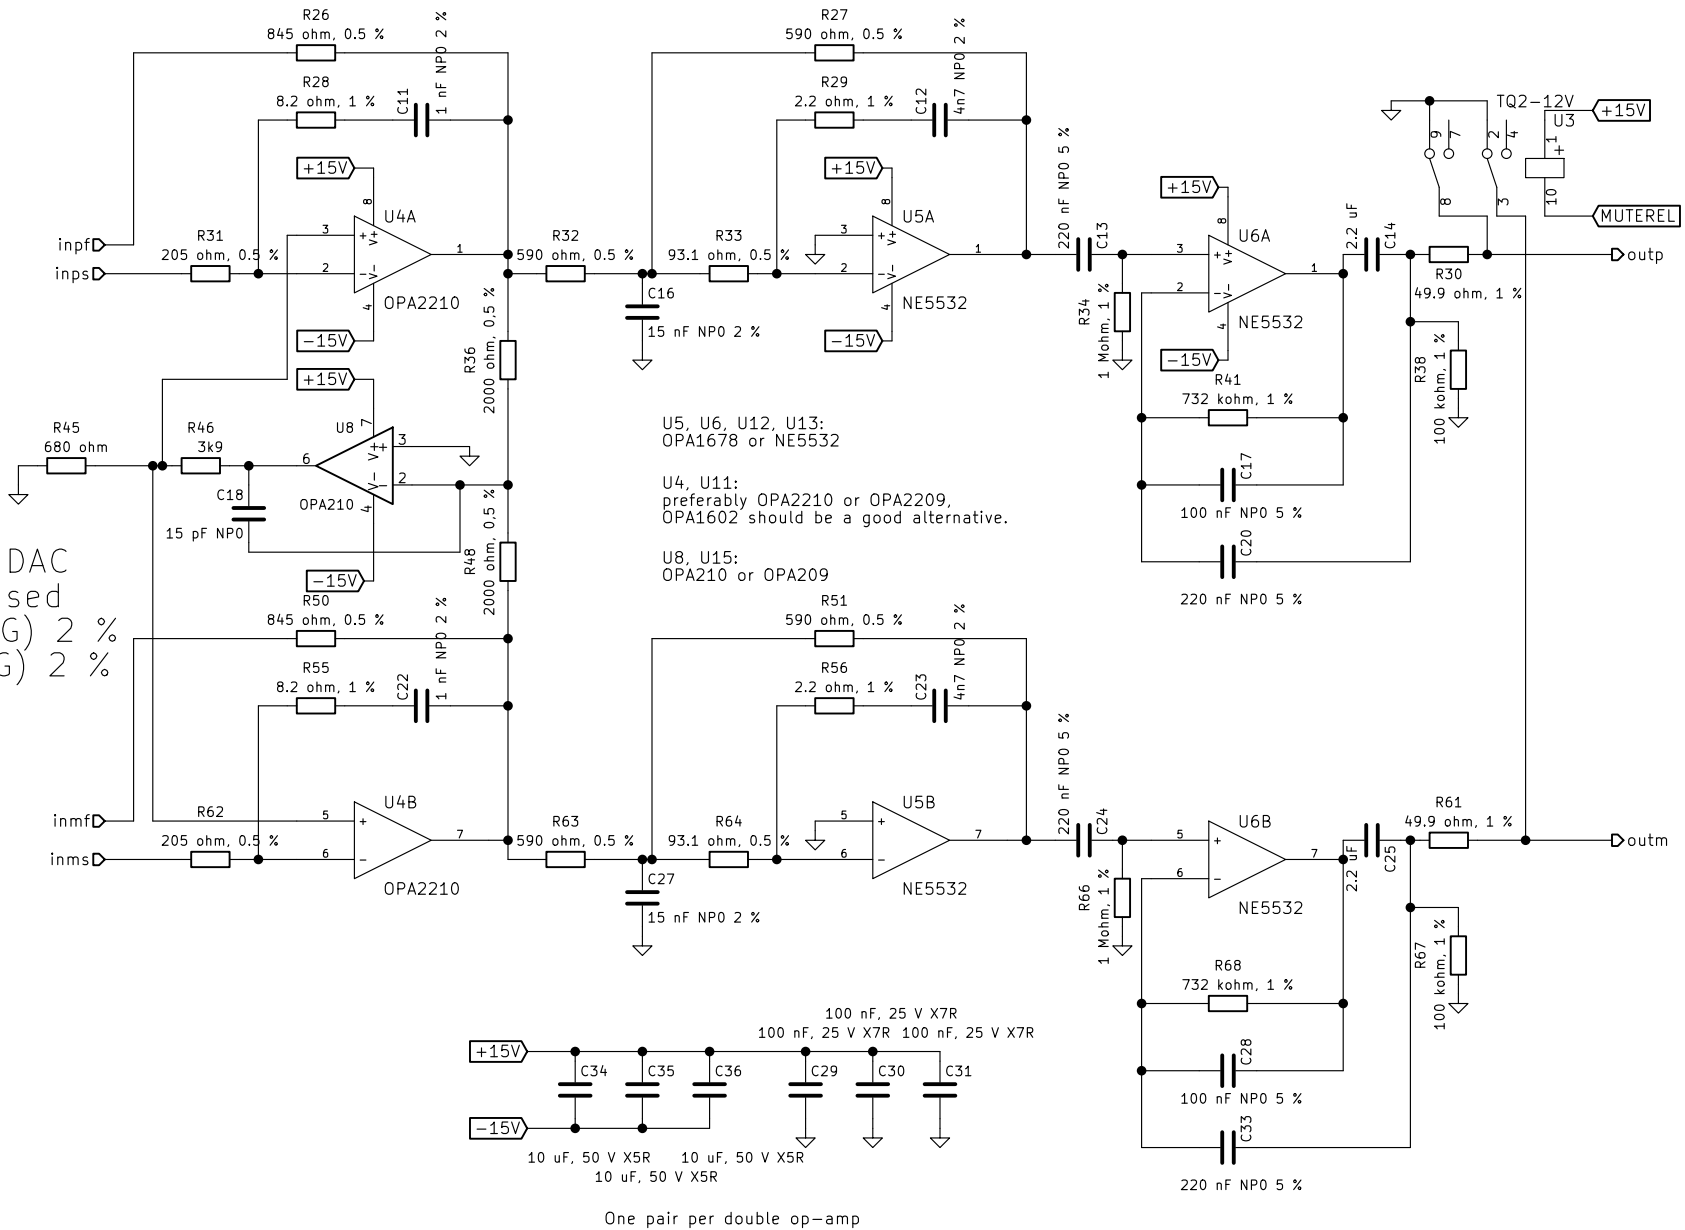
All DAC and filter resistors thin film

Capacitors on the DAC board to be increased from 8n2 NP0 (C0G) 2 % to 22 nF NP0 (C0G) 2 %

All DAC and filter resistors thin film

Capacitors on the DAC board to be increased from 8n2 NP0 (C0G) 2 % to 22 nF NP0 (C0G) 2 %
